Subject: MHI's Response to US-APWR DCD RAI No. 982-6036 (SRP 06.03)

Response to Request for Additional Information No. 982-6036

**US-APWR Design Certification
Mitsubishi Heavy Industries
Docket No. 52-021**

RAI No.: 982-6036
SRP Section: 06.03 – Emergency Core Cooling System
Application Section: 06.03
DATE of RAI issue: 12/18/2012

Figure 2.4.4-1 Emergency Core Cooling System (Sheet 1 of 4)

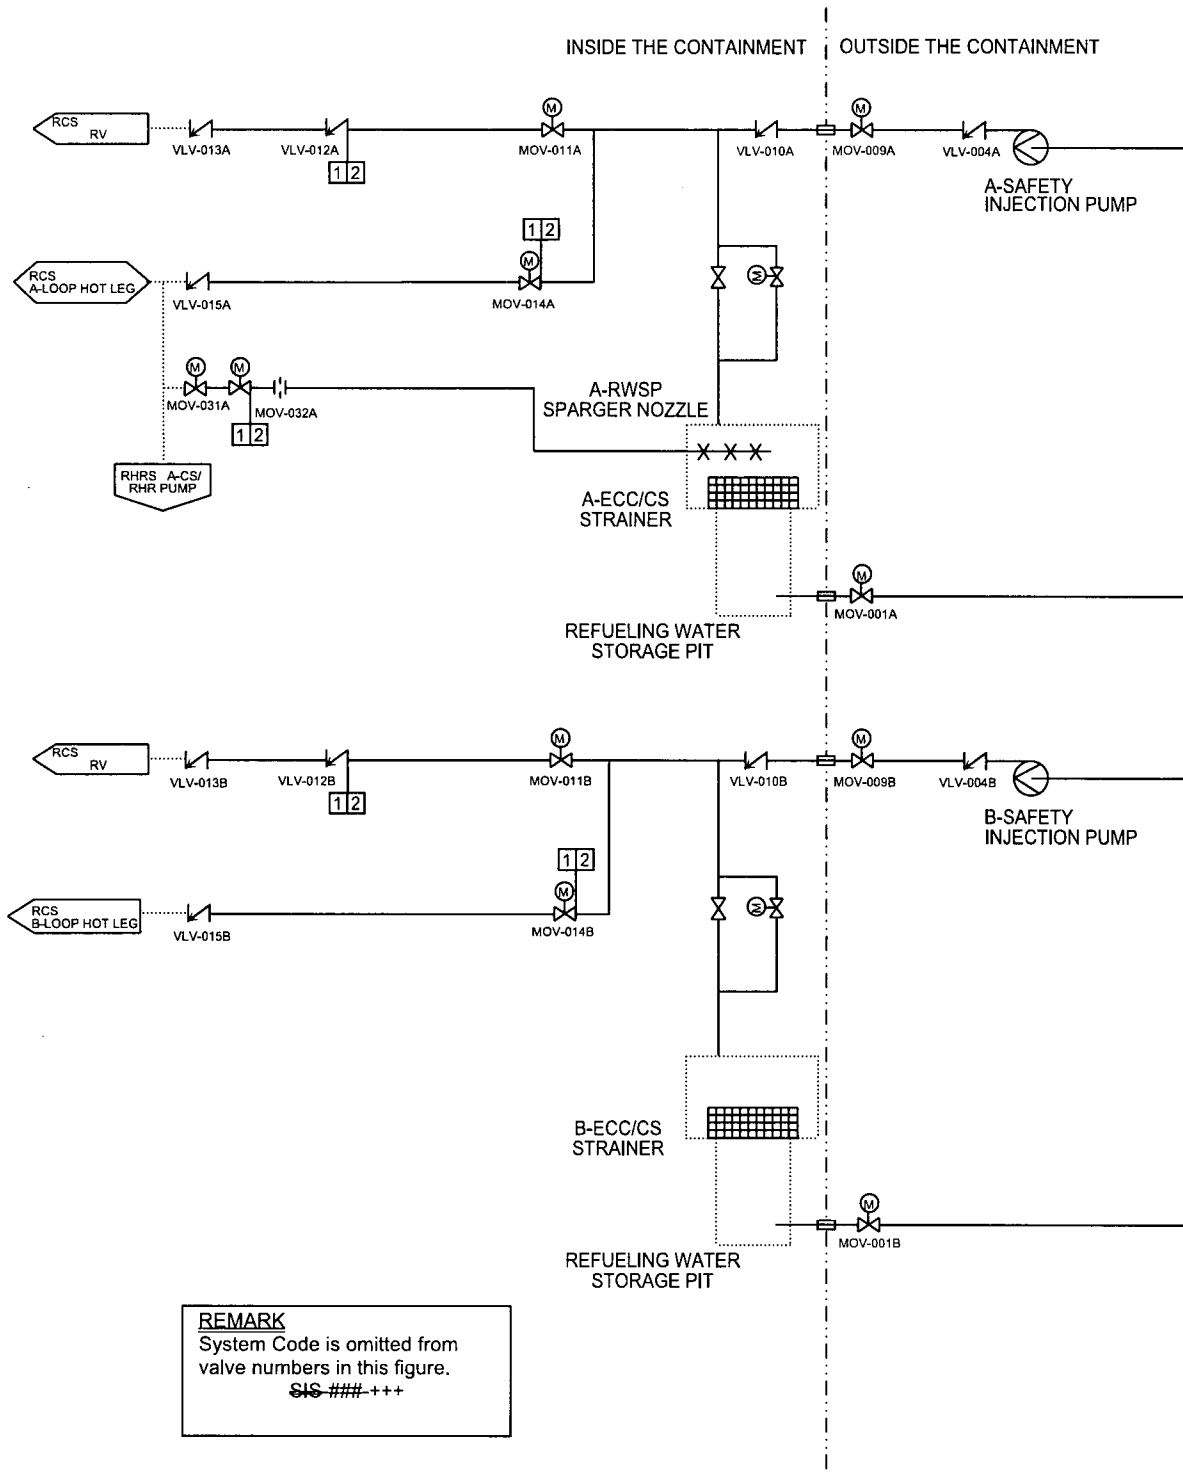
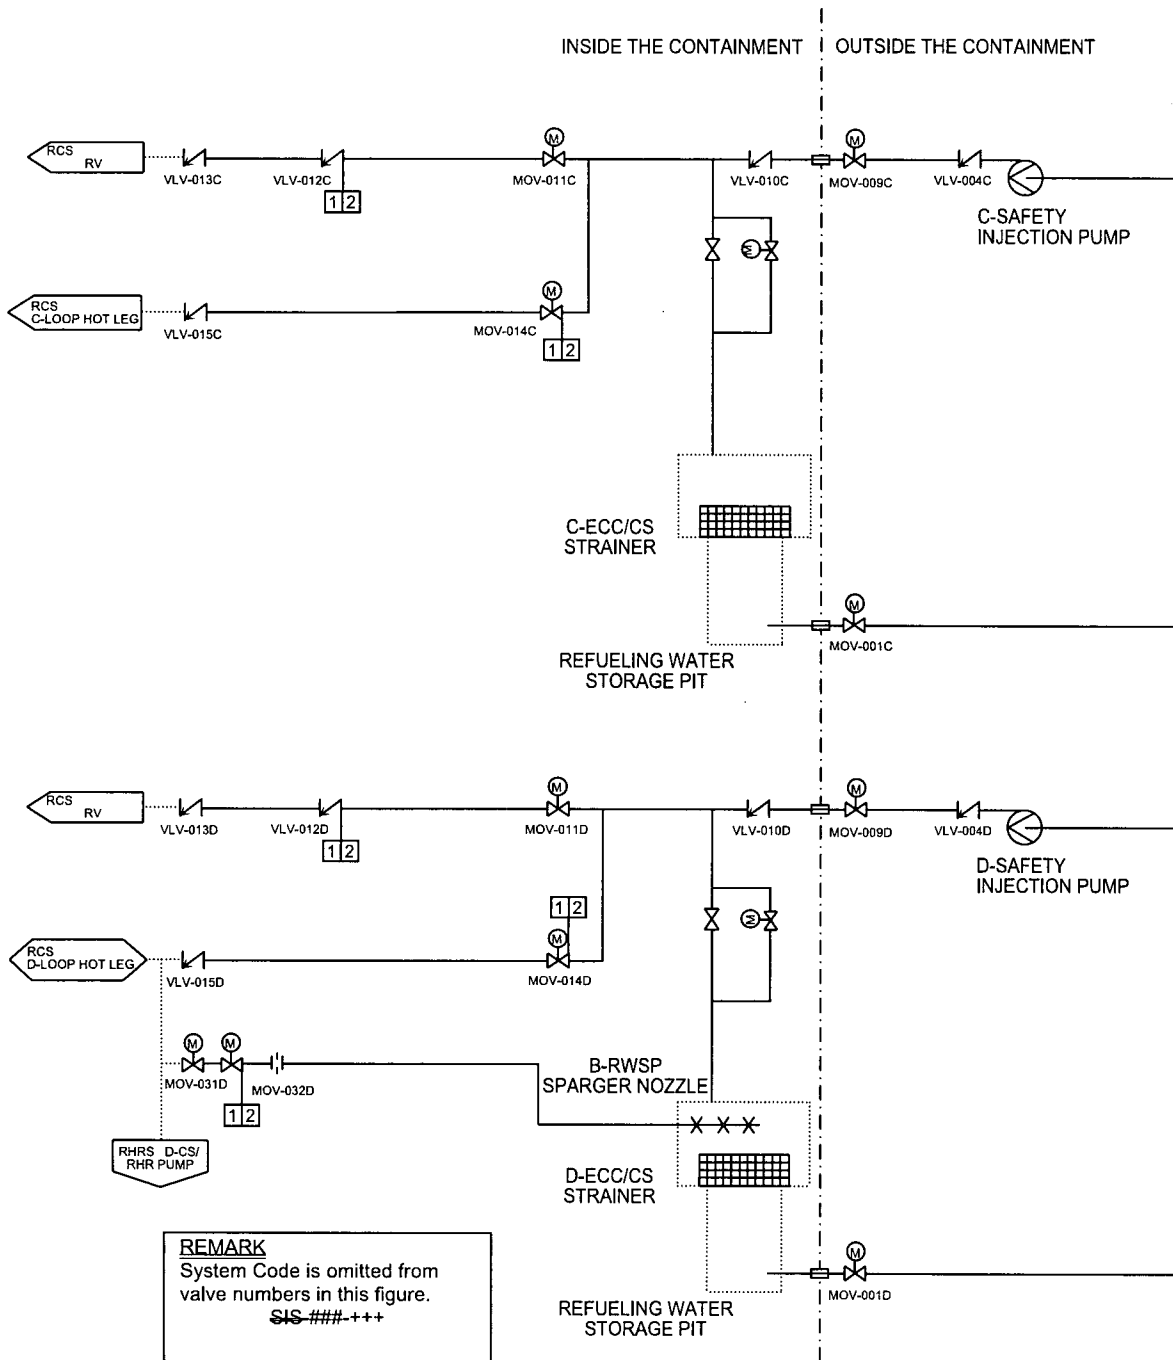
DCD Tier 1 Table 2.4.4-1, Table 2.4.4-2, Table 2.4.4-3, and Figure 2.4.4-1, and DCD Tier 2 Chapter 3, Table 3.2-2 are revised as shown in the attached mark-ups to clarify that the emergency letdown system spargers are within the scope of the existing ITAAC.

DCD Tier 1 Table 2.4.4-1, Table 2.4.4-2, Table 2.4.4-3, Figure 2.4.4-1, and DCD Tier 2 Chapter 3, Table 3.2-2 are revised as shown in the attached mark-ups.
